Clonburris SDZ,
Dublin 22

Ronan Mac Diarmada & Associates

ADDITIONAL INFORMATION RESPONSE

November 2022

Phasing Plan

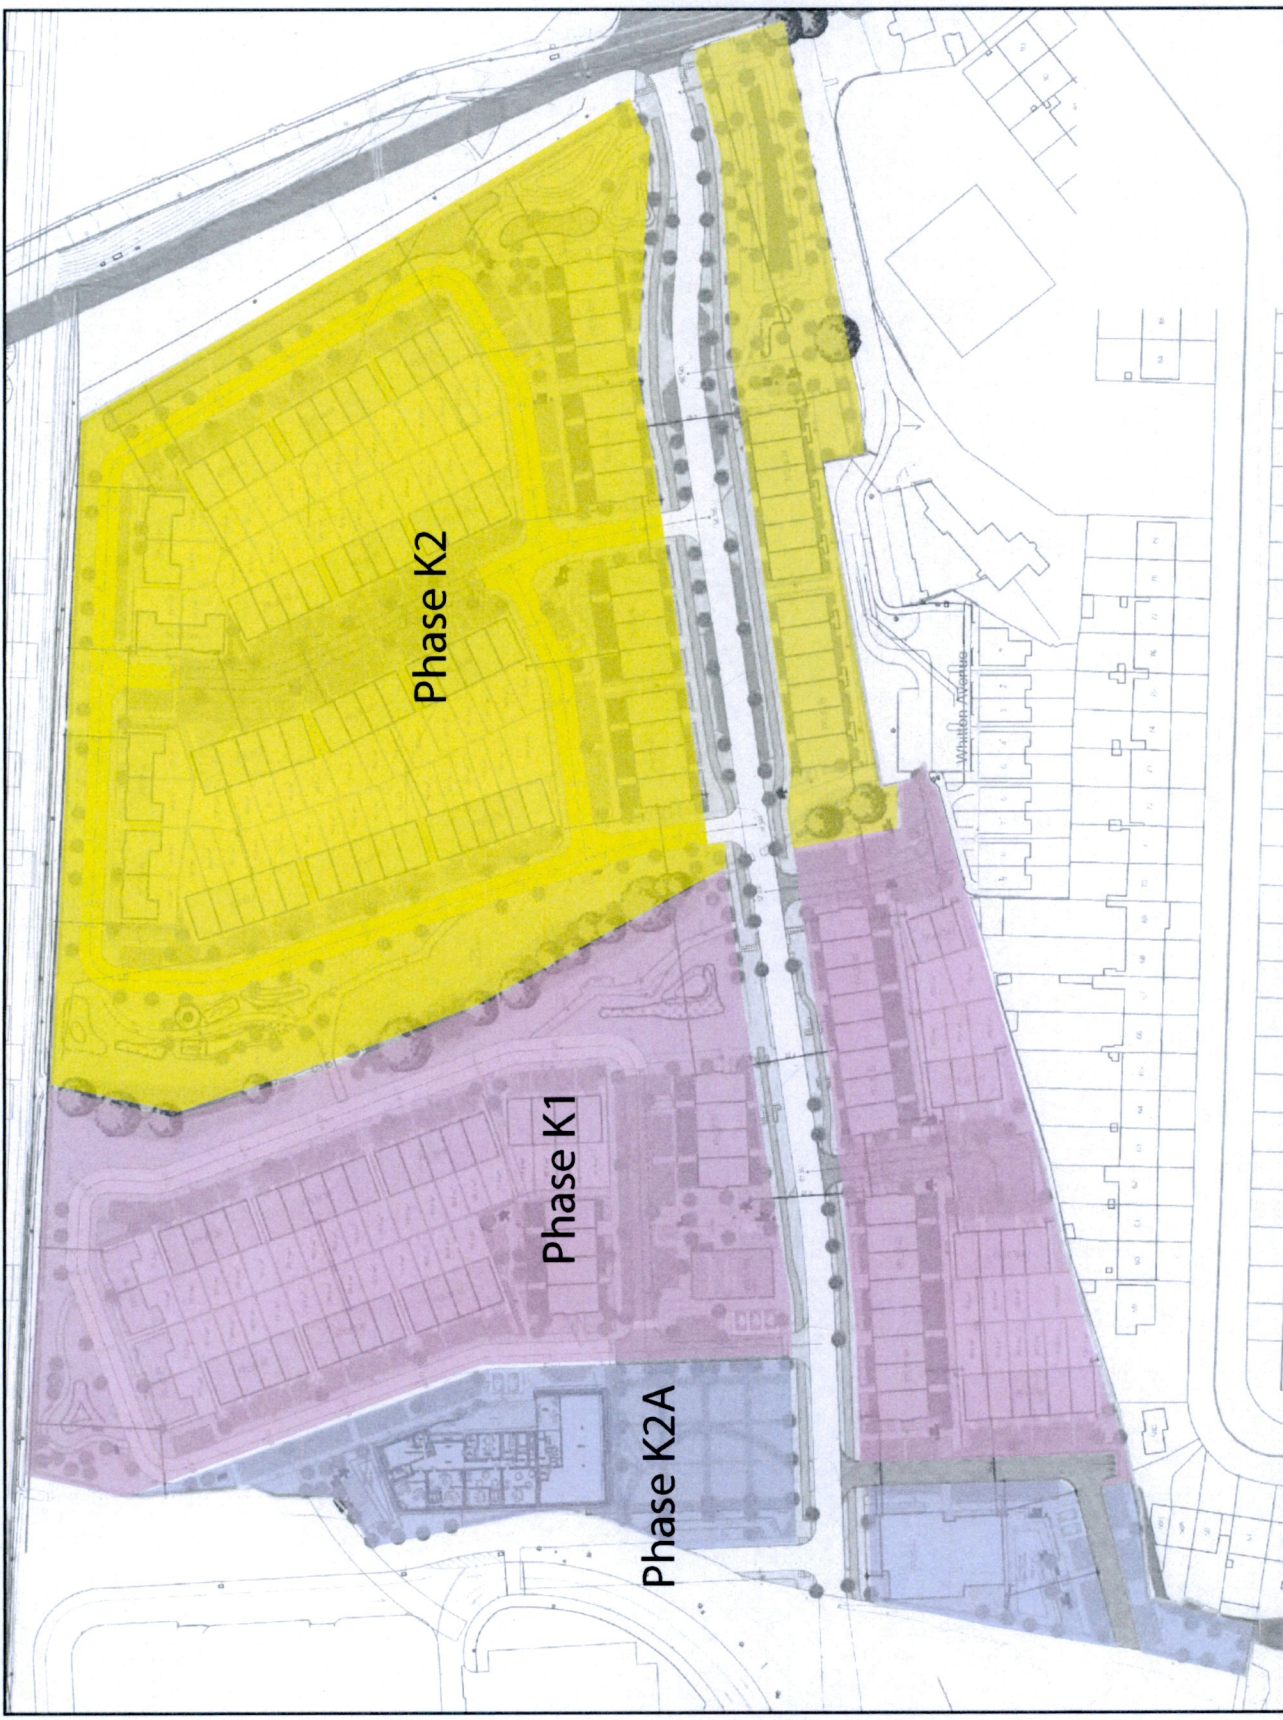
Implementation timetables

Implementation shall be carried out on a phased basis. Please refer to phasing plan.

Boundary Treatment Plan

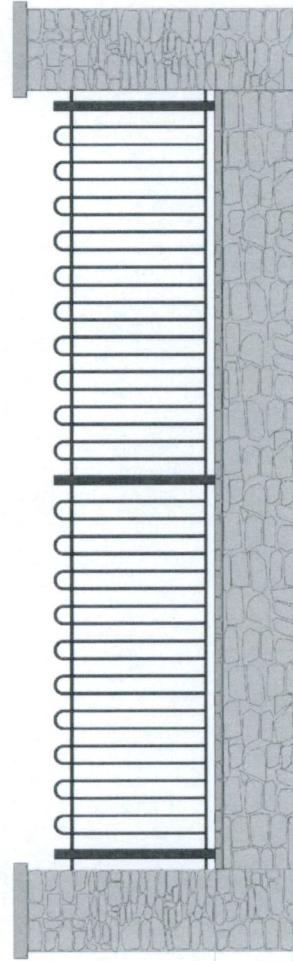
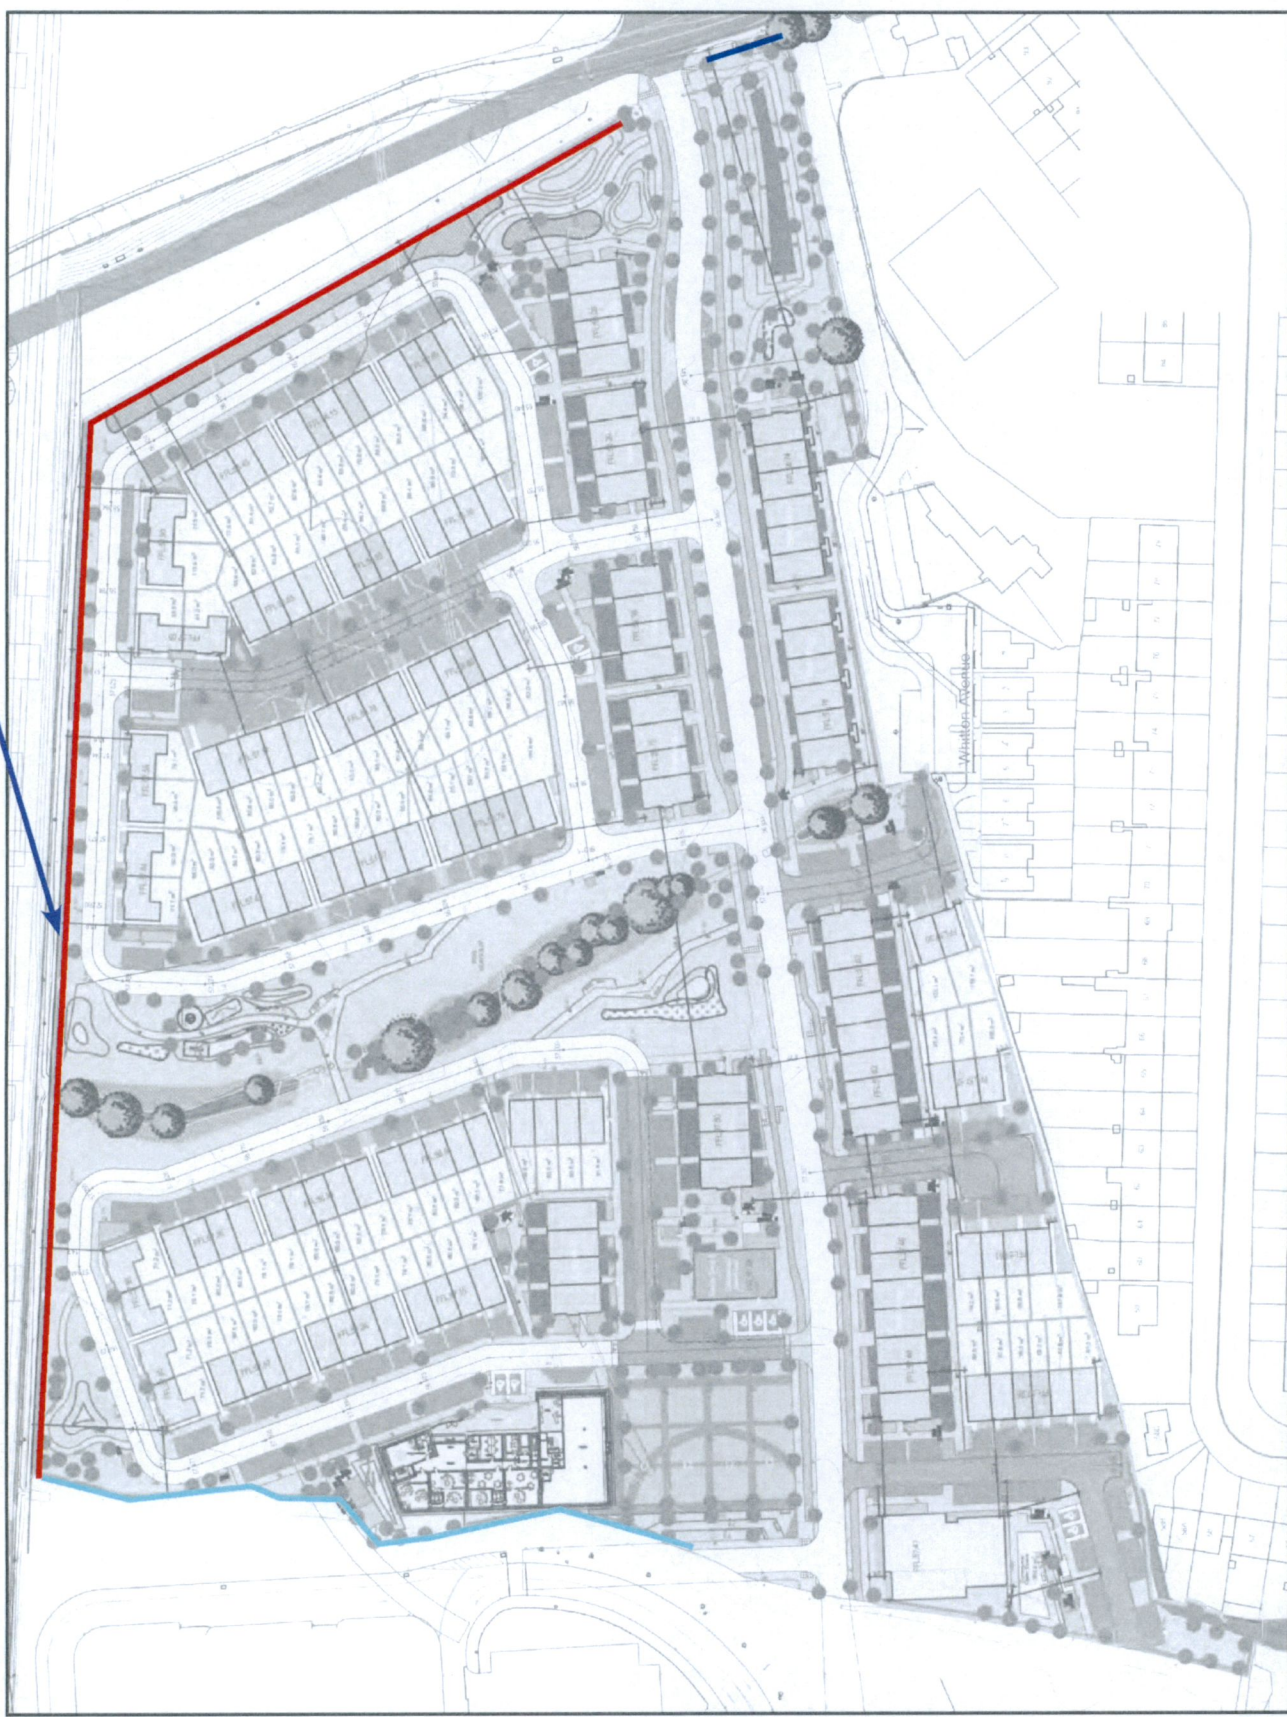
Local Park boundaries to have railing suitable to public realm, i.e. a permanent low wall with heavy duty round bar, minimum 16mm diameter galvanised and powder coated matt black metal railing, 1.8m high, suitable for public realm or a permanent 2m high wall.

We propose to keep the existing boundary treatment running from east to north.
The western boundary treatment shall be a stone butt wall & bowtop railing

Retained Hedge & New Implemented Hedge Plan

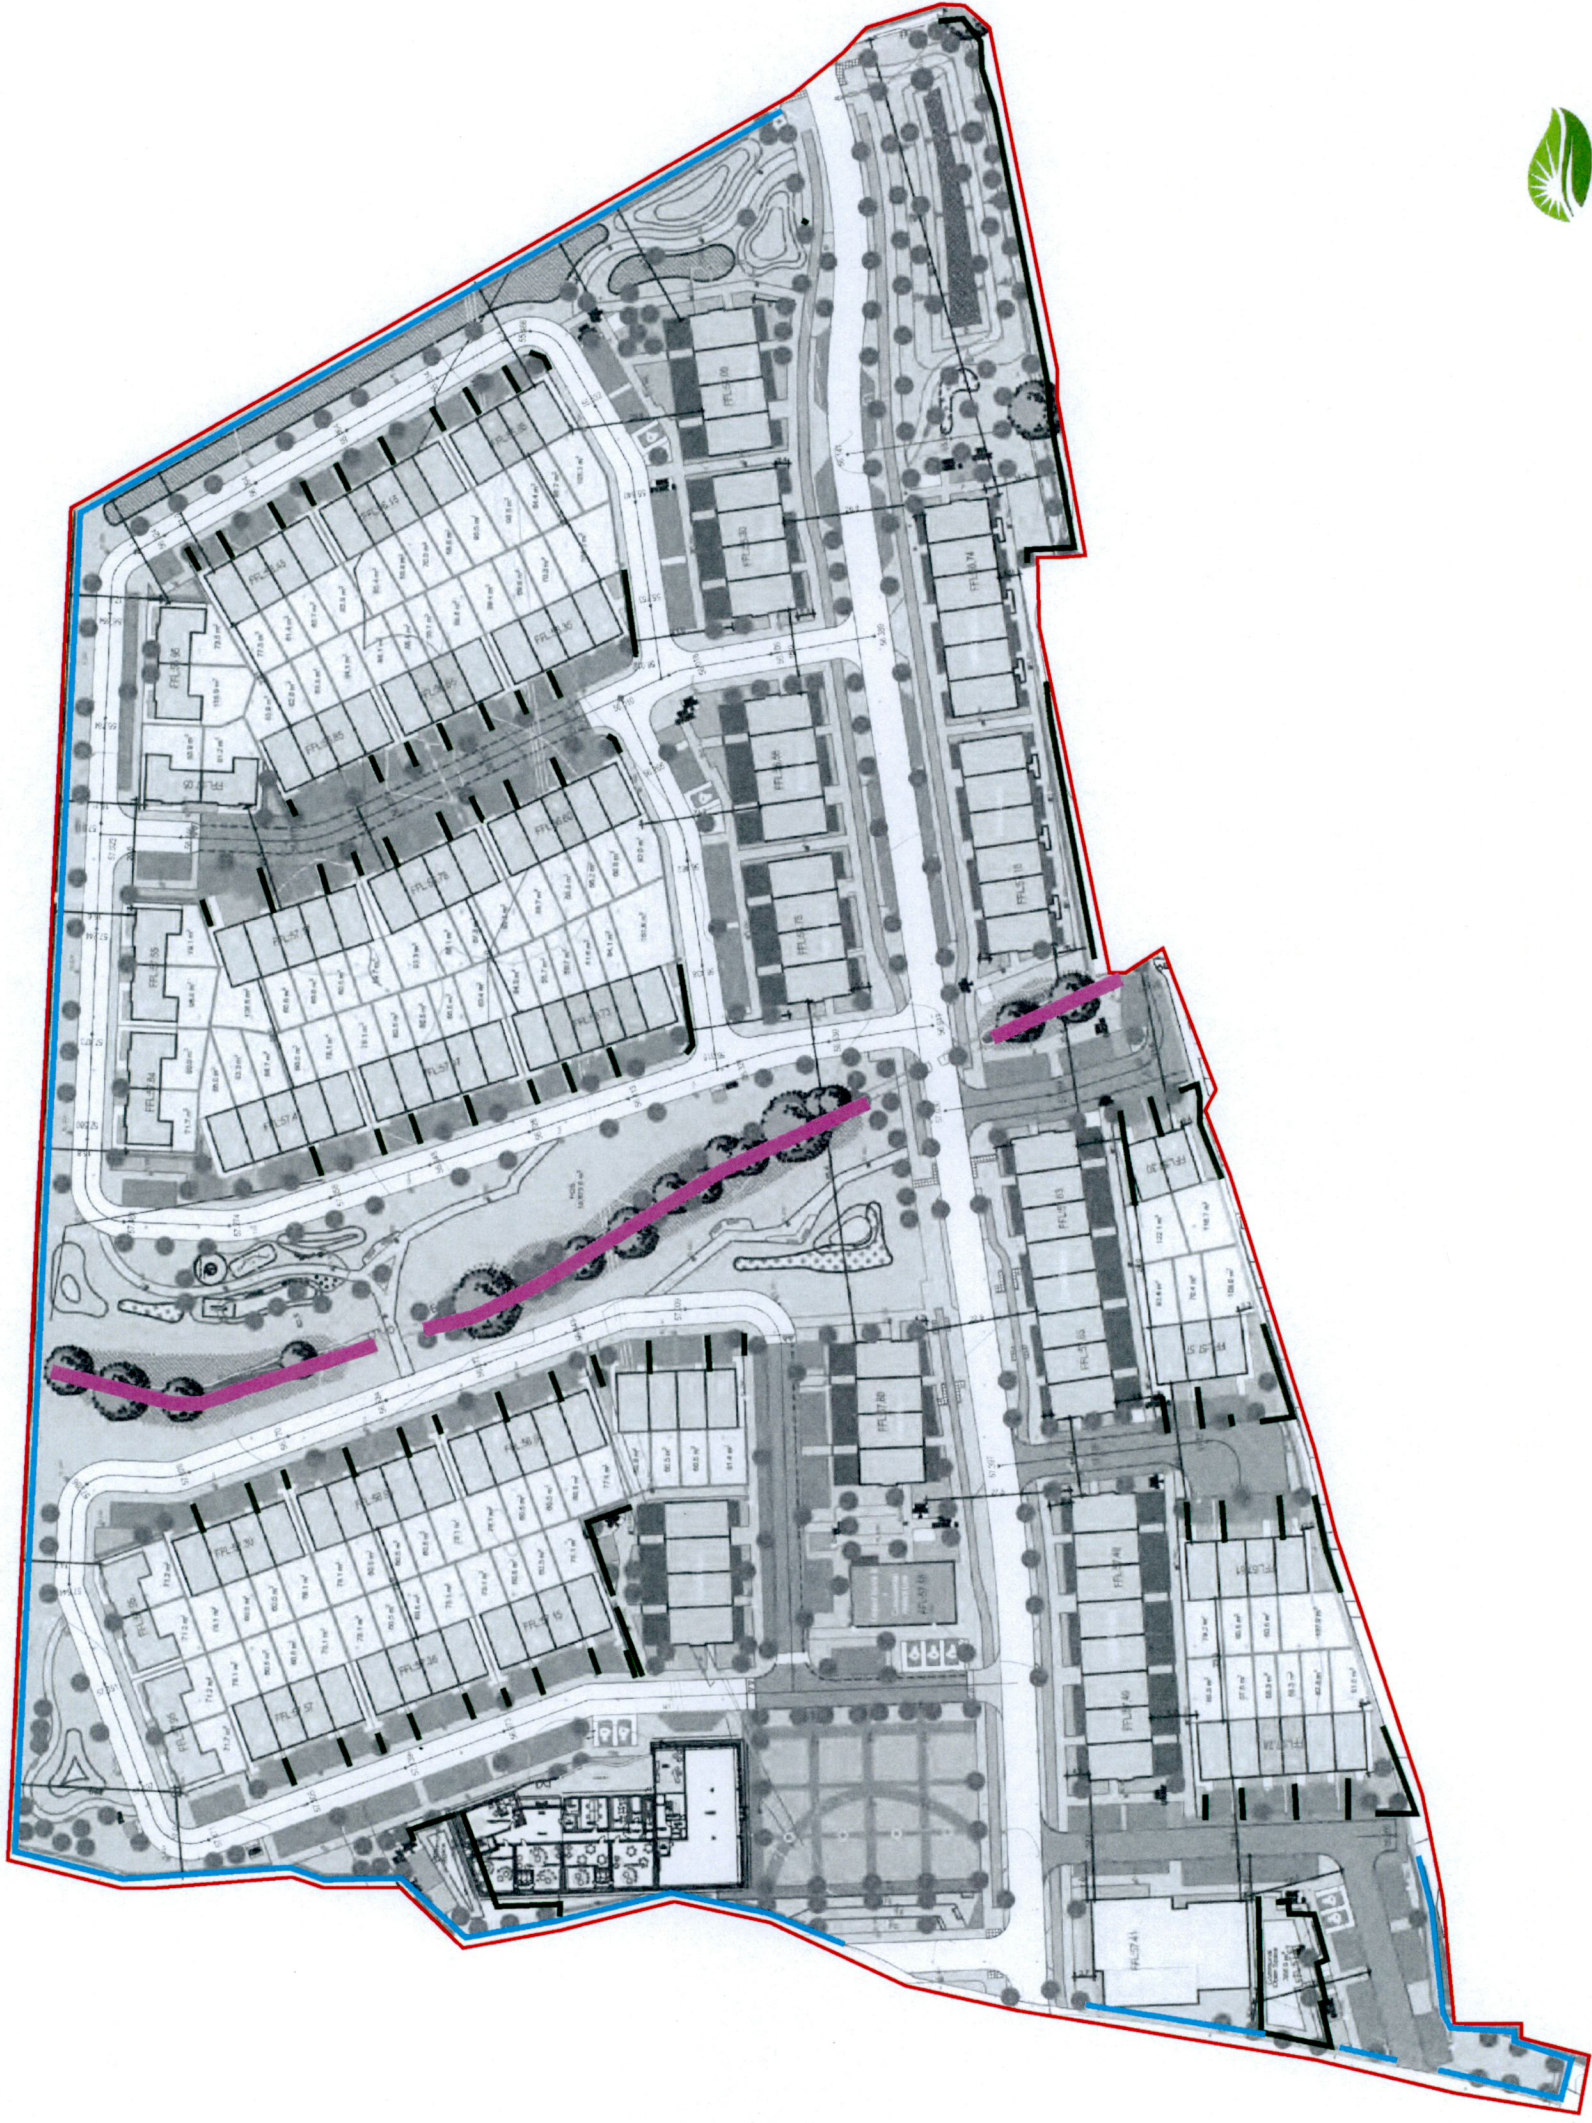
Woodland planting should use the Miyawaki technique (3-5/m²) in order to establish quickly and reduce maintenance costs. This will require an establishment period and maintenance of 5 years for newly planted woodland areas prior to taking in charge

Woodland planting will follow the Miyawaki technique. The taking in charge shall be maximum 18 month from completion of the development.

Dust Path & Play area Location Plan

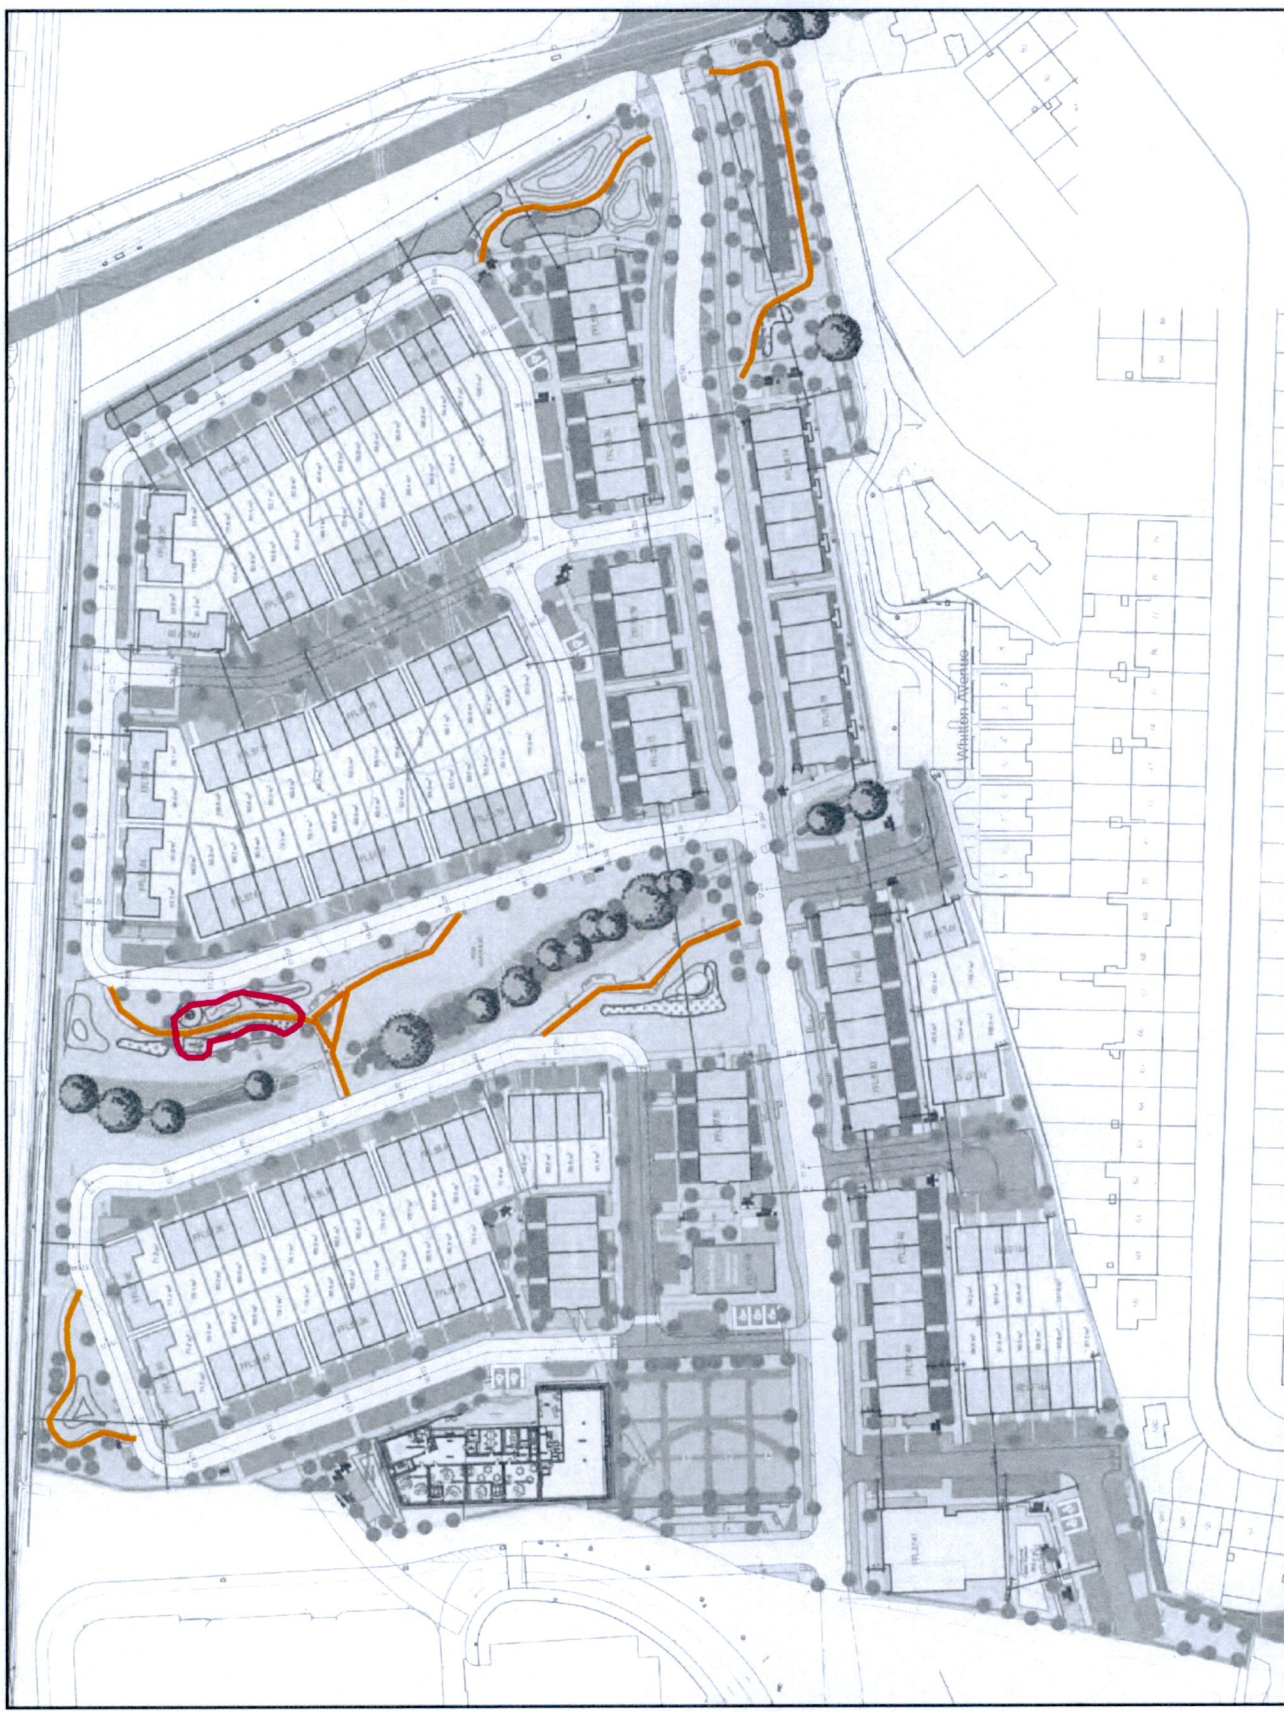
Paths to be a permeable solid surface within flood attenuation areas.

All playspace surfacing to be engineered woodchip surfacing.

Paving shall be dust to attenuation area to avoid hydrocarbons from tarmac

All playspace surfacing located in the development to be engineered woodchip surfacing.
